SHEARON HARRIS NUCLEAR POWER PLANT, UNIT NO. 1
DOCKET NO. 50-400/RENEWED LICENSE NO. NPF-63
RESPONSE TO REQUEST FOR ADDITIONAL INFORMATION REGARDING THE
LICENSE AMENDMENT REQUEST TO REVISE TECHNICAL SPECIFICATION
3.7.5a, ULTIMATE HEAT SINK MAIN RESERVOIR MINIMUM LEVEL

SHEARON HARRIS NUCLEAR POWER PLANT, UNIT NO. 1
DOCKET NO. 50-400/RENEWED LICENSE NO. NPF-63
RESPONSE TO REQUEST FOR ADDITIONAL INFORMATION REGARDING THE
LICENSE AMENDMENT REQUEST TO REVISE TECHNICAL SPECIFICATION 3.7.5a,
ULTIMATE HEAT SINK MAIN RESERVOIR MINIMUM LEVEL

Subject: Request for License Amendment of Technical Specification 3.7.5a,
"Ultimate Heat Sink" to recover margin in Main Reservoir minimum
allowed level

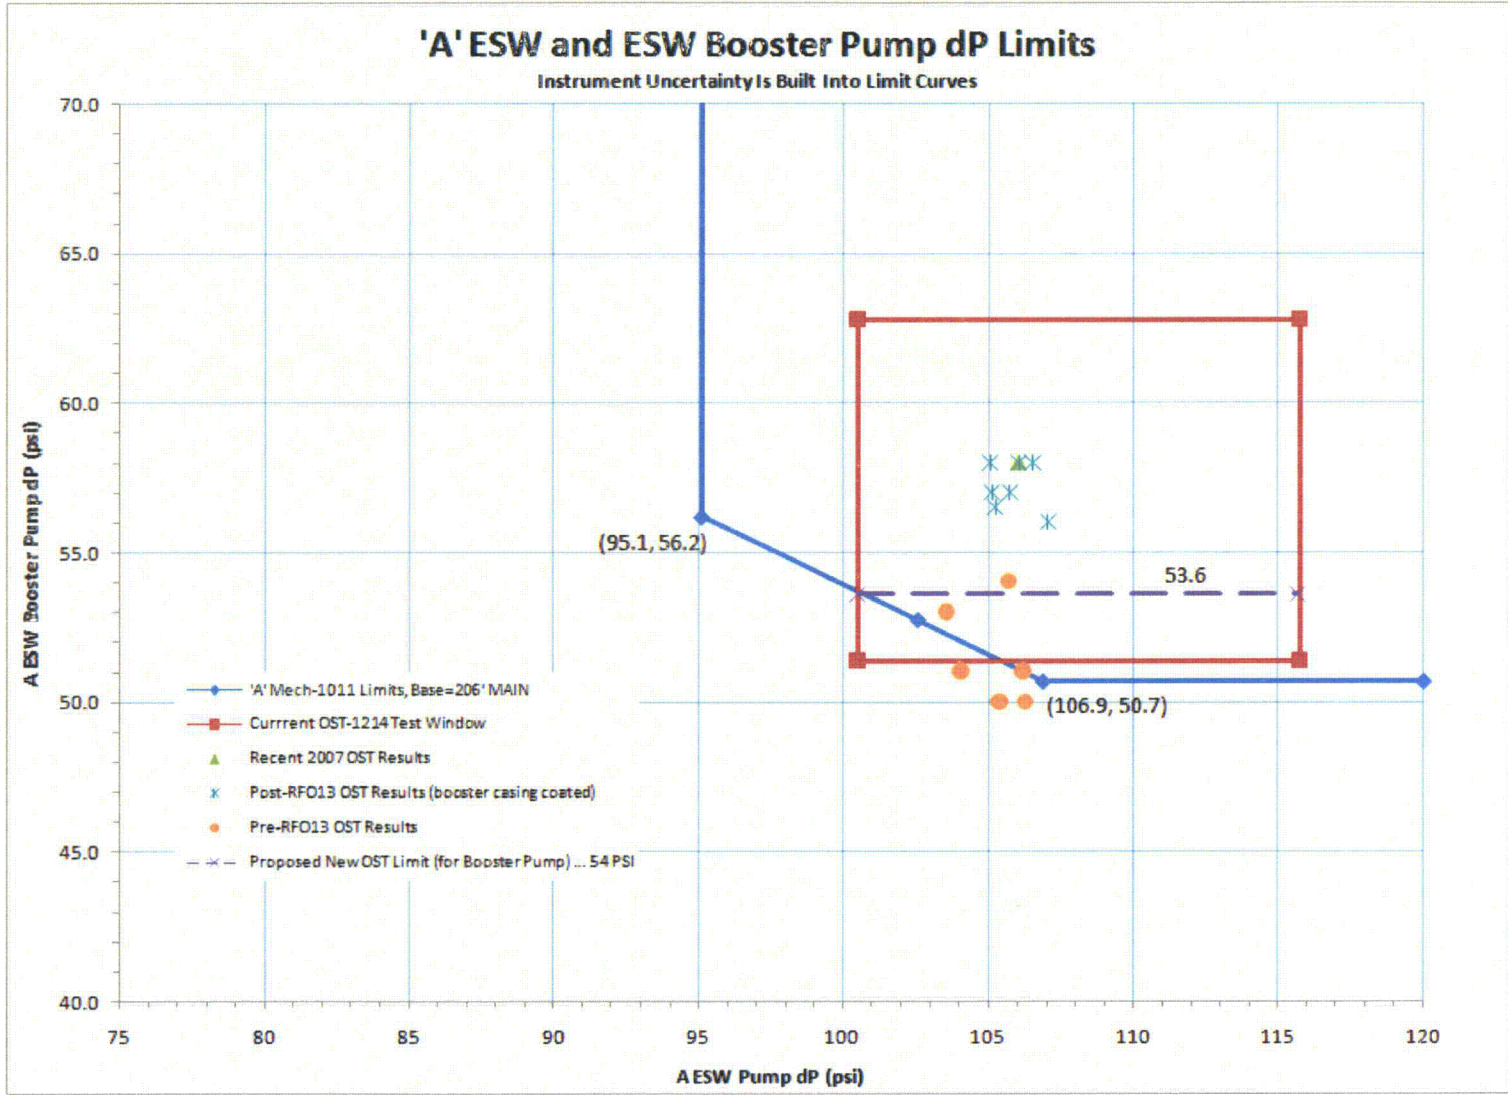
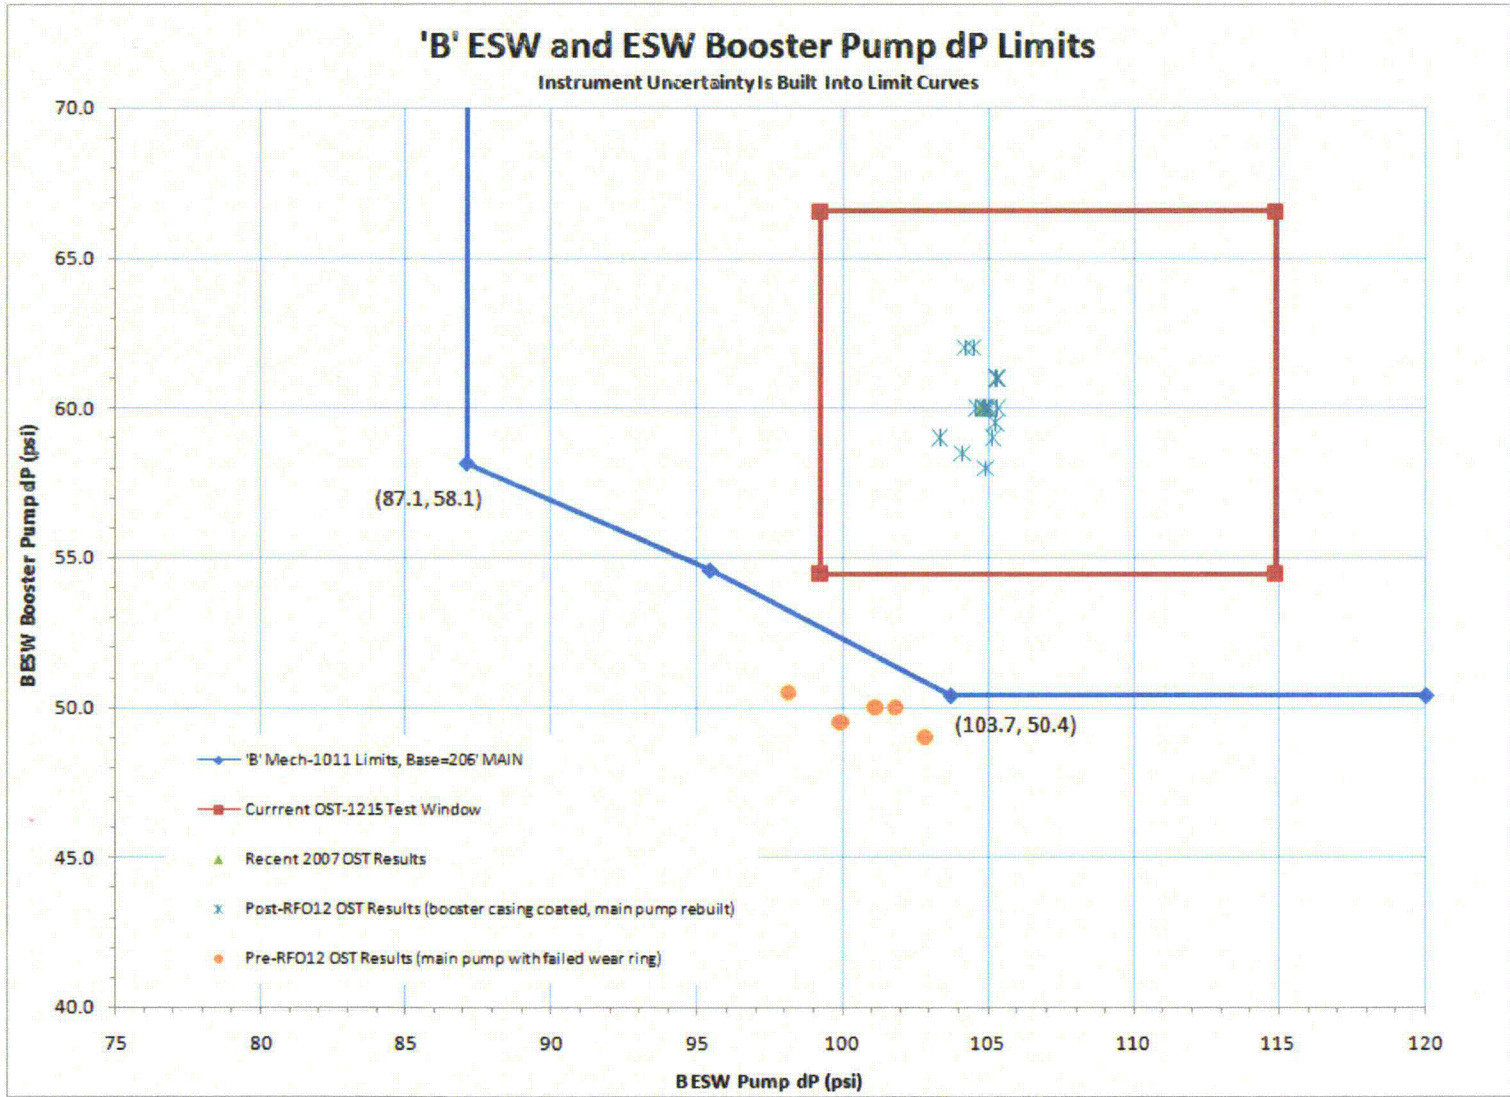
Section 4.2 of the LAR states that calculation HNP-M/MECH-1011 demonstrates that there is positive pressure margin available with a 206 feet minimum level in the Main Reservoir. Since the ESW Pumps and the ESW Booster Pumps both contribute to ESW pressure inside containment, the figures shown in the submittal provide the minimum allowable pump differential pressures for both pumps of each train on a single graph. The NRC staff is not clear as to how the licensee generated the figures in the LAR shown on pages 10 of 23 and 11 of 23, and how these figures demonstrate that the licensee will continue to meet the minimum service water pressure requirements inside the containment coolers.

Request 7: Section 4.2 of the LAR states that the results of calculation HNP-M/MECH-1011 show that ESW pressure, not flow, currently defines the available ESW system margin. Do the differential pressure limits shown in the figures on pages 10 of 23 and 11 of 23 in the LAR reflect limits based on ESW flow or ESW pressure or both? Please explain.

Since the ESW Pumps and ESW Booster Pumps both contribute to ESW pressure inside containment, HNP-M/MECH-1011 provides the minimum allowable pump differential pressures (dP) for both pumps for each train on a single graph. This allows for various combinations of limits between the ESW and ESW Booster Pumps. The calculation also graphs the current Operations Surveillance Test (OST) limits and some recent and historical OST data against the new pump dP limits. These graphs are shown on pages 12 and 13 of Enclosure 1.

Each graph shows the limits of pump performance based on the ability to maintain ESW pressure above 41.8 PSIG. Because the ability of the ESW system to maintain minimum pressure is more limiting than the ability to provide minimum flow, all areas on the graph which ensure acceptable system pressure also ensure acceptable system flow.

Response 1: Reference revised Enclosure 1, "HNP Evaluation of the Proposed Change," page 10. Note that the figures on pages 10 of 23 and 11 of 23 referenced above in RAI 2 were based on the original submittal. These figures are now located on pages 12 of 24 and 13 of 24 of revised Enclosure 1.

Response 7: Reference revised Enclosure 1, "HNP Evaluation of the Proposed Change," page 9. Note that the figures on pages 10 of 23 and 11 of 23 referenced above in RAI 2 were based on the original submittal. These figures are now located on pages 12 of 24 and 13 of 24 of revised Enclosure 1.
